Evaluation of proposed move for Water Right No. 10841 D1

Proposed: Move water right no. 10841 D1 to a new well location 1,471 ft to the northwest.

Project: 10841 D1

Location: Meade County

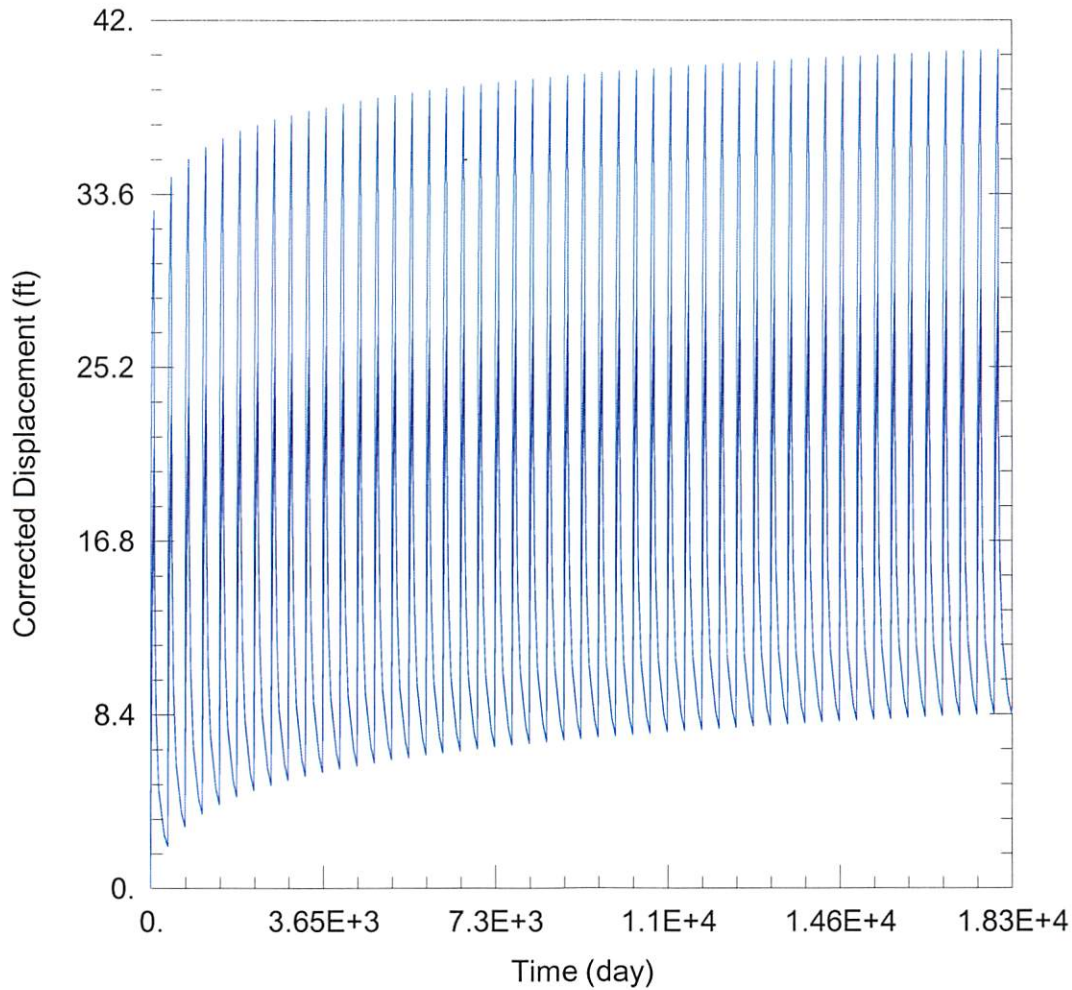
The proposed change is located near an area with a prior impairment investigation. During this investigation, a pumping test was conducted in 2009, and the specific yield (S) and transmissivity (T) values used to determine well-to-well drawdown effects were drawn from the results of that pumping test. These values are considerably lower than much of the high plains aquifer, and as a result, the calculated well-to-well drawdown effects are very large, and dynamic drawdown requirements (the depth a local well draws into the aquifer to access the water it is currently using) are also very high.

All wells with certified water rights in the area were found to be critical, meaning they are likely to be impaired. In some cases, the total drawdown effects over the next 25 years, when aquifer decline and dynamic drawdown requirements are considered, are estimated to exceed the remaining saturated thickness. These large declines are not actually possible. Instead, the proposed well will likely be incapable of pumping its full annual rate and quantity, and neighboring wells will experience drastic declines in well productivity due to the inability to draw as deep into the aquifer to access a water supply.

Given the information available, it is difficult for GMD3 staff to recommend approval of the application. It is possible that a local aquifer test may prove this area to be different than the location tested in 2009. Better data may provide different results and recommendation. It is also possible that the applicant may agree to a limitation of rate and quantity so that neighboring wells are not flagged as critical through this review process, though those reductions would need to be significant if the aquifer values used are

Data Set: C:\Users\trevora\Documents\2021_Moves\10841D1\10841 Current.aqt

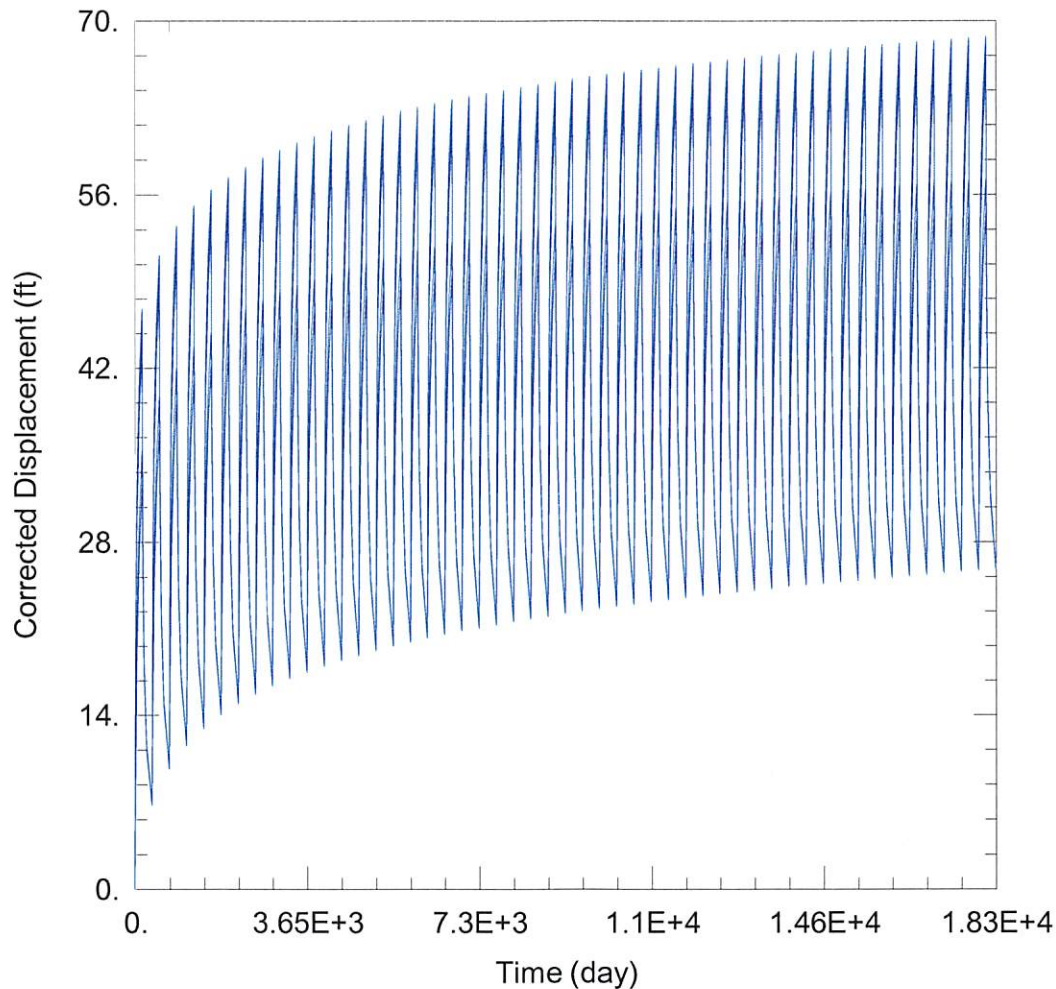
44494:	Drawdown from current location = 26.3 ft
	Drawdown from proposed location = 67.3 ft
	Net drawdown = 41.0 ft
30093:	Drawdown from current location = 28.1 ft
	Drawdown from proposed location = 68.7 ft
	Net drawdown = 40.7 ft

13386: Drawdown from current location = 25.9 ft
Drawdown from proposed location = 57.2 ft
Net drawdown = **31.3 ft**

42316: Drawdown from current location = 40.6 ft
Drawdown from proposed location = 65.8 ft
Net drawdown = **25.2 ft**

10841 D2: Drawdown from current location = 29.0 ft
Drawdown from proposed location = 54.5 ft
Net drawdown = **25.5 ft**

Domestic 10-31-27: Drawdown from current location = 28.5 ft
Drawdown from proposed location = 54.5 ft
Net drawdown = **26.0 ft**

Net drawdown exceeds the drawdown allowance of 4.0 ft for all wells within 1 mile of the proposed location. Critical well analysis is necessary on those wells.
